**Addendum No. 4
September 2, 2022**

Project: **St. Mary Catholic School Addition & Remodel**
812 N. State Avenue
Dell Rapids, South Dakota 57022
Architecture Incorporated Project #2788

Architect: Architecture Incorporated

DRAWING SHEET 9.20 – BASEMENT FLOOR PLAN – DEMO – ELECTRICAL

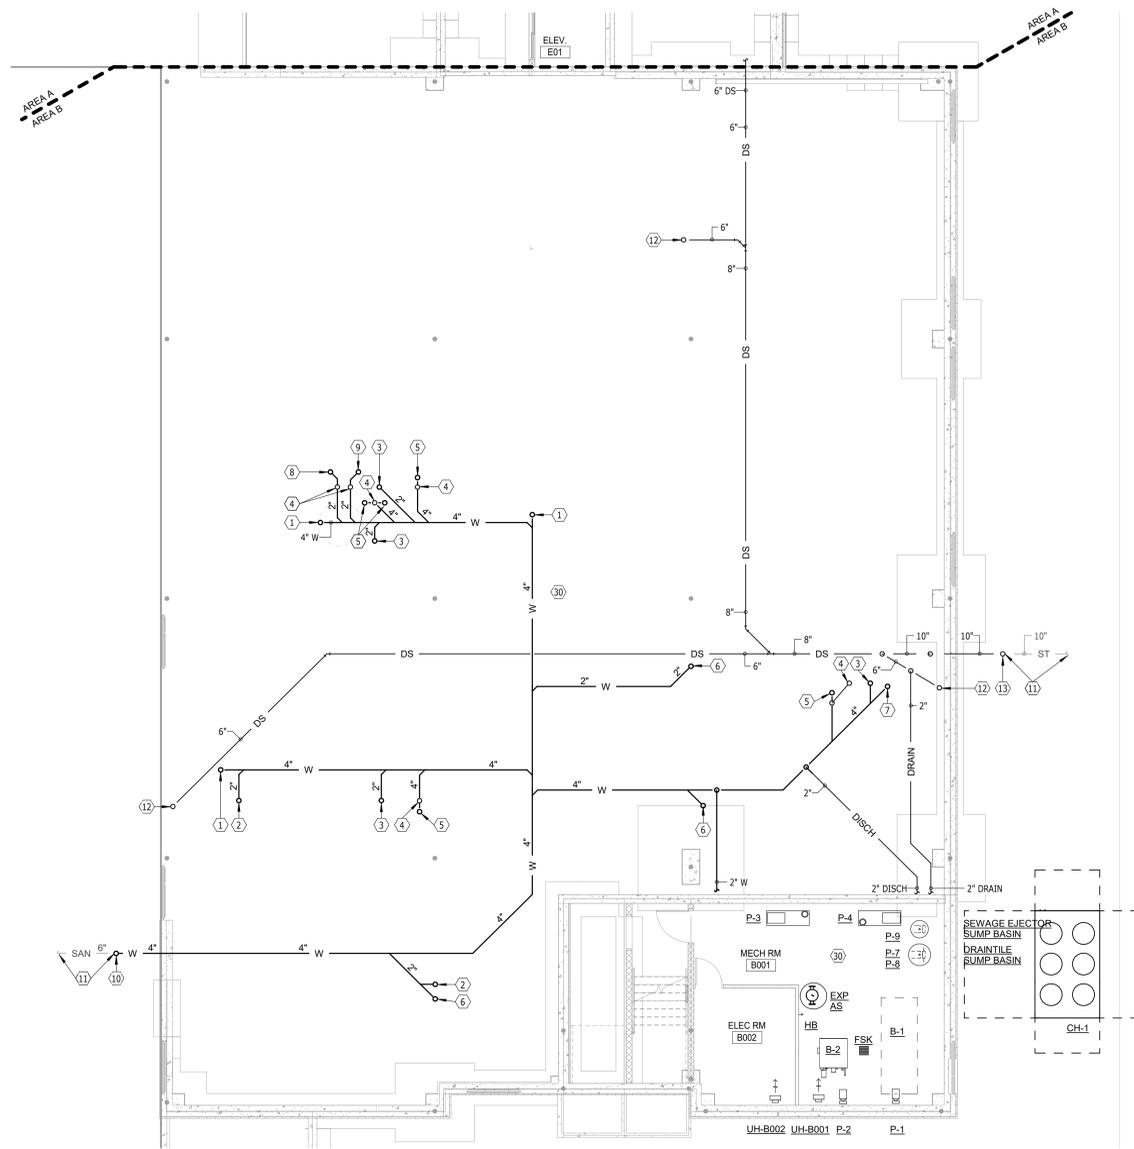
1. Delete electrical note #5 (the ceiling fans shall be new in lieu of existing).

8.31

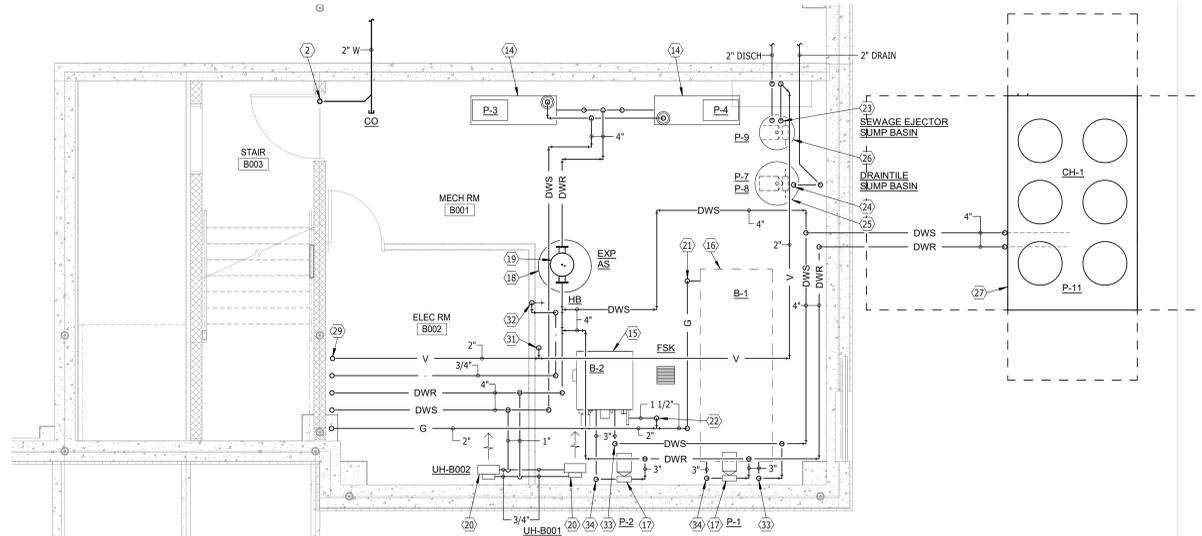
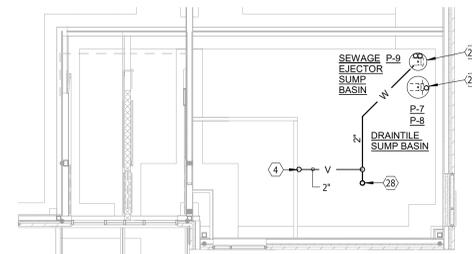
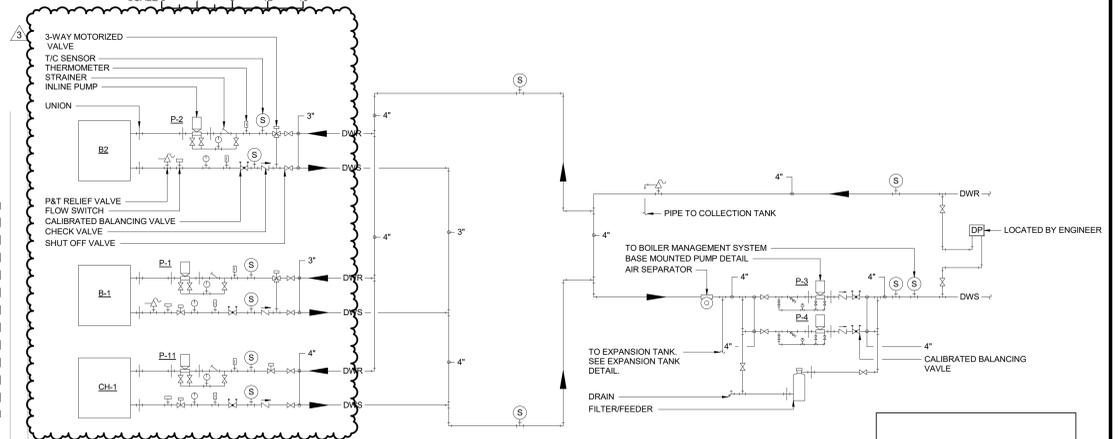
1. BOILER PIPING DETAIL:
 - a. Add 3-way control valve and modify check valve location. Refer to revised drawings sheet 8.31, HEATING/COOLING SYSTEM DIAGRAM, ADDENDUM 3, dated 9/2/22.

DRAWING SHEET 8.31 – ENLARGED GROUND FLOOR PLAN – AREA B – PLUMBING & HEATING

1. HEATING/COOLING SYSTEM DIAGRAM
 - a. Modify piping diagram for 3-way control valve and revised check valve location. Refer to revised drawings sheet 8.31, HEATING/COOLING SYSTEM DIAGRAM, ADDENDUM 3, dated 9/2/22.
2. Plumbing note #18
 - a. Modify note as shown on revised drawings sheet 8.31, ADDENDUM #3, dated 9/2/22.

SECOND FLOOR PLAN - AREA A - VENTILATION & A/C
 SCALE: 1" = 16'

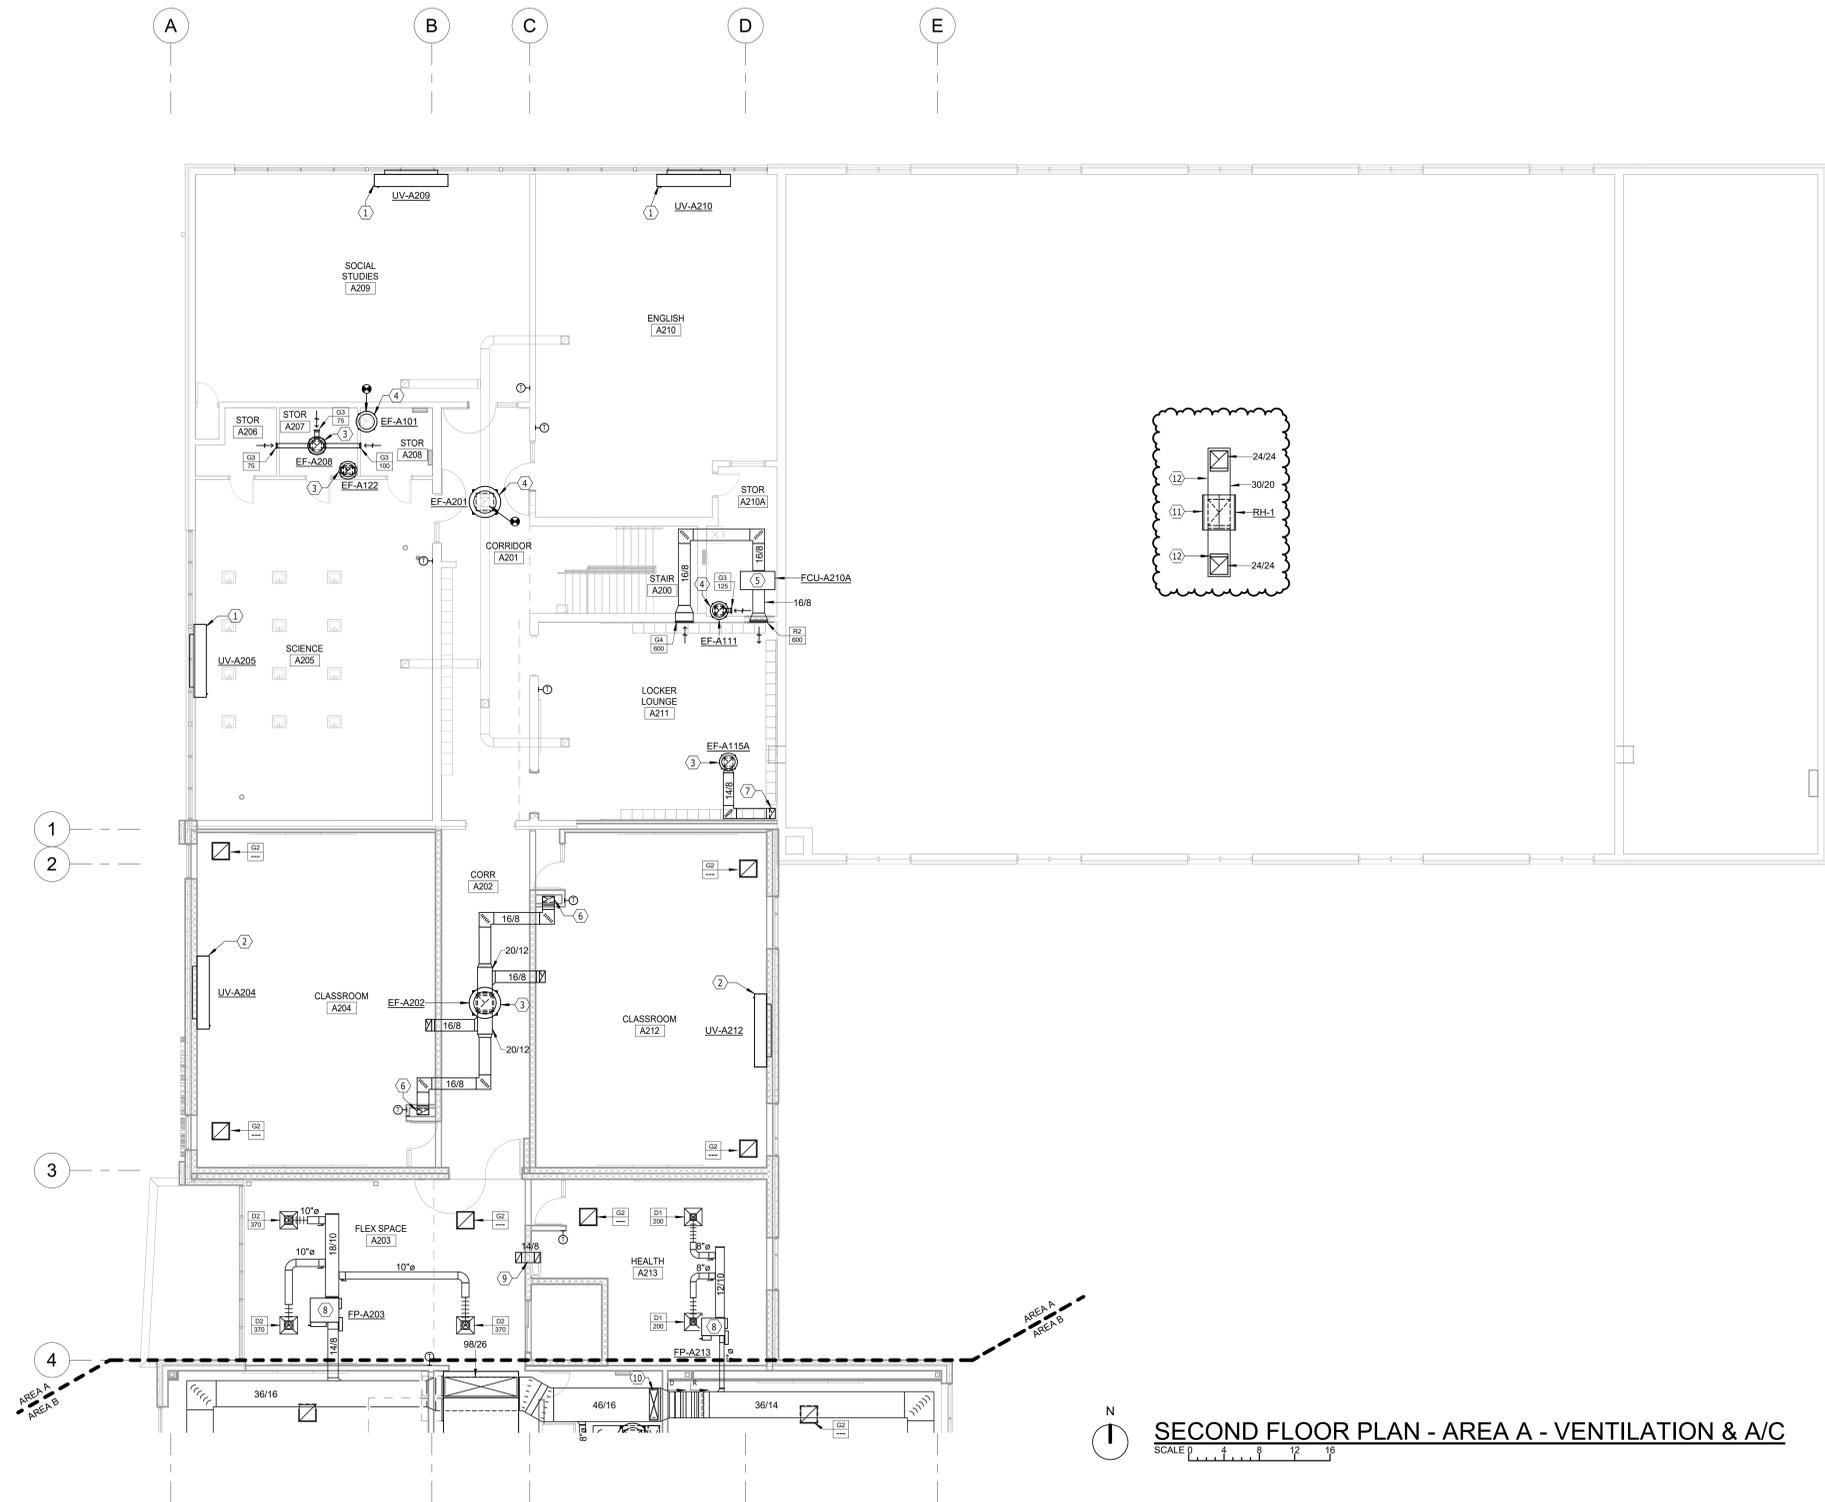
a) **Structural Item for Mechanical Sheet 8.54: Second Floor Plan – Area A – Vent. & A/C**

- i) At all new openings in existing steel roof deck, provide a new welded angle frame around the new opening in the steel deck and under mechanical equipment per detail 6/3.7.3. Install L1 1/2x1 1/2x3/16 reinforcing angles as required on each side of the existing steel roof joists per details 2/3.7.2 and 8/3.7.2.

DRAWING SHEET 8.54 – SECOND FLOOR PLAN – AREA A – VENT & A/C

1. Add relief hood to existing gym as shown on revised drawings sheet 8.54, ADDENDUM 3, dated 9/2/22.

- 10. 24/24 DOWN THROUGH FLOOR.
 - 11. RELIEF HOOD SIMILAR TO GREENHECK MODEL FGR-30036. PROVIDE WITH COUNTER BALANCE BACKDRAFT DAMPER AND MOUNT ON INSULATED ROOF CURB. PROVIDE INSULATED DROP AND DRIP PAN.
